Docket Item # 7  
BAR CASE# 2008-0023

BAR Meeting  
May 21, 2008

**ISSUE:** Alterations  
**APPLICANT:** Boyd Walker  
**LOCATION:** 200 Commerce Street  
**ZONE:** CL/Commercial Low

Figure 2. Proposed elevation.

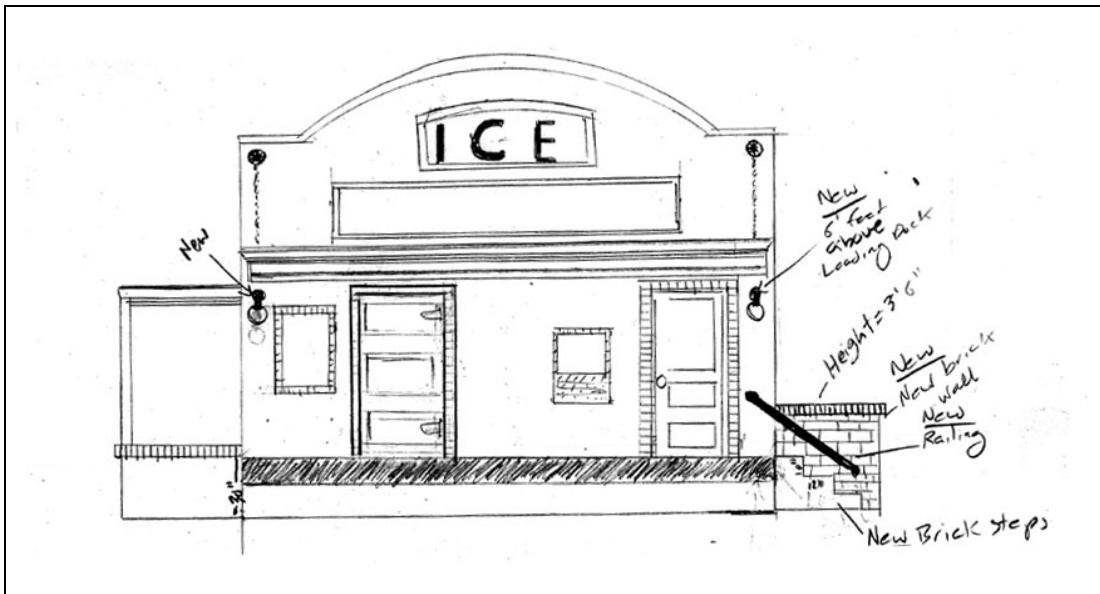
**REASON:** The changes proposed by Mr. Walker for the fence and material were unclear and the Board believed that further clarification was necessary before action could be taken. The Board requested professionally produced drawings that were proportional, in scale and accurately portrayed what was being requested. The Board also requested a detail drawing of the brick wall cap.

While Staff has no objections to the proposed alterations which are both practical and meet the recommendations contained in the *Design Guidelines*, staff does not believe that the proposal is responsive to the comments of the Board at the last public hearing. At that time the Board asked for professionally produced drawings that would enable the Board to accurately visualize the applicant's proposal. The drawings submitted by the applicant for this hearing provide a general idea of the work that is proposed, but are not fully dimensioned and do not fully specify materials and construction details as requested by the Board members. Staff is also concerned about the installation of the bollards and how they will function to delineate parking in the paved

Figure 3. Proposed side elevation.

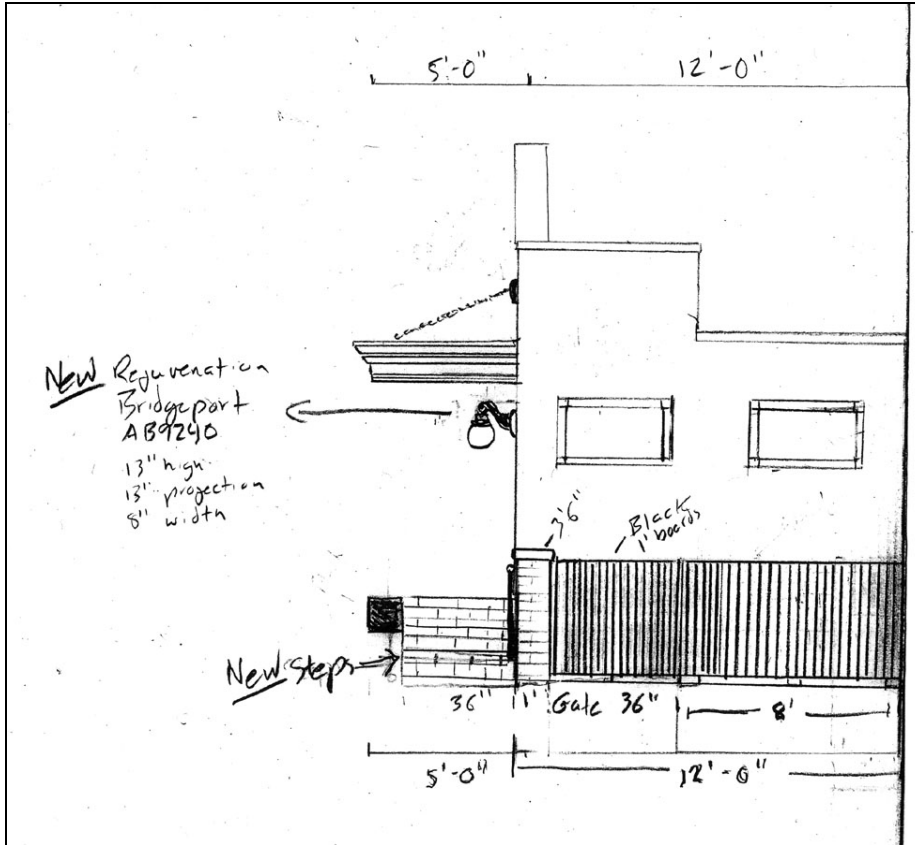
- New steps. A set of new brick steps leading to the loading dock landing will be constructed at the west side of the building. The steps will be 36" in width. A metal railing will be installed on the new brick wall along the steps.

F-1 Stairs must comply with USBC for riser and tread dimensions.

C-4 The new handrails must comply with USBC for a minimum/maximum height of 30 to 34 inches. The ends must extend 12" beyond the top and bottom risers. The handgrip position must not be more than 2-1/4" in cross-sectional dimension, or the shape must provide an equivalent gripping surface. The handgrip portion must have a smooth surface with no sharp corners. The space between the wall and handrail must not be less than 1-1/2".
